TS/KS
09389
5 May 2016

**SECOND ADDENDUM LETTER TO MP09_0167
45 MACQUARIE STREET, PARRAMATTA**

Figure 1 – Comparison of approved plans submitted under Modification 4, and submitted plans under Modification 5, demonstrating the removal of building masts.

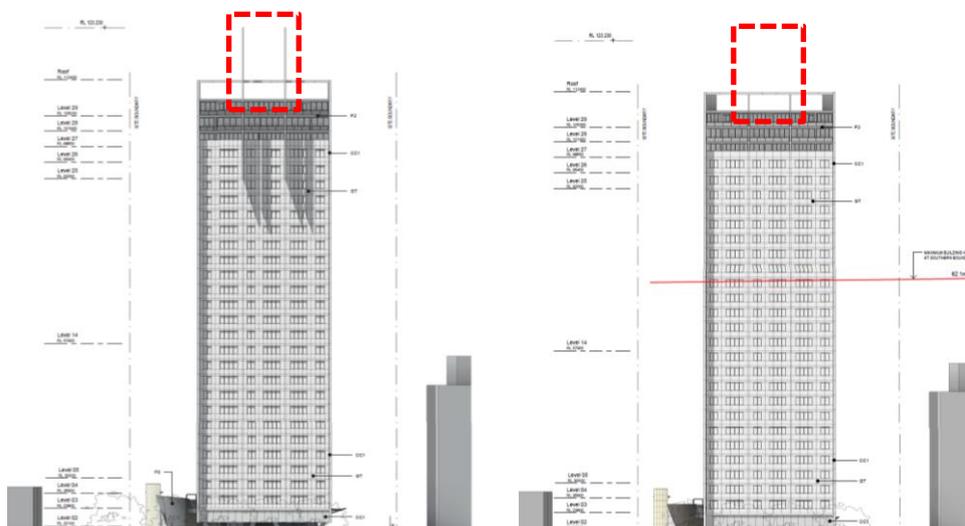
An amendment was made in the submitted plans regarding the removal of two approved lightning masts. This amendment to the design was a result of detailed design development and construction methodology, and a comparison between the approved masts and the proposed design without the masts has been produced at **Figure 1** below.

An email sent from Matthew Rosel on 13 May 2015 confirmed that this proposed amendment would not trigger the requirement for an additional Section 75W Modification Application, as the only changed element of the design was the removal of the masts. This email has been reproduced for reference of the Department at **Attachment A**, and accordingly this change has been incorporated into Modification 5.

Figure 2 – Comparison of approved plans submitted under Modification 4, and submitted plans under Modification 6 demonstrating the amendment to the signage at drawing SK01
Source: AJ + C

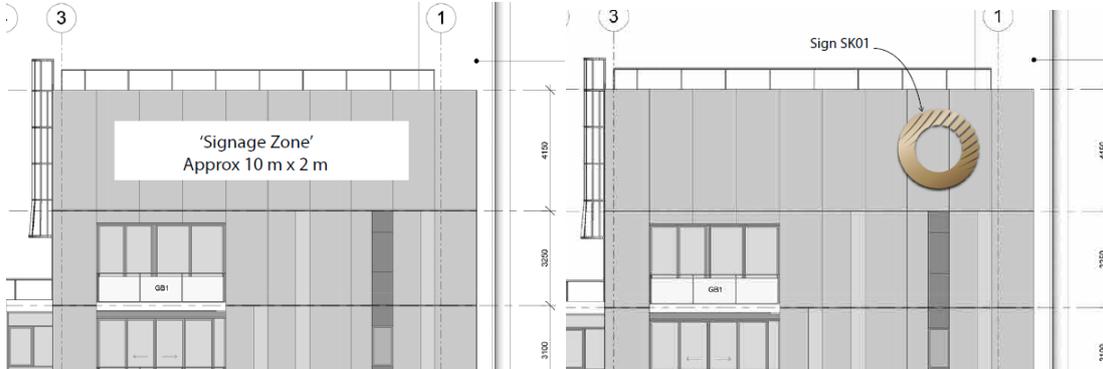
Approved under Modification 4 as part of the submitted Signage Plans was approval for a 10m x 2m 'signage zone' at the eastern elevation of the site, known as sign SK01. As part of Modification 5, an amendment has been made to Plan SK01 in order to formalise the sign as the Crown Group Logo, as opposed to the use of a signage zone.

There will be no adverse impacts arising from this minor change in the provision of signage at the site. The amended sign will not affect the previous assessment of Schedule 1 of SEPP 64, and accordingly this minor change of the signage is worthy of approval.
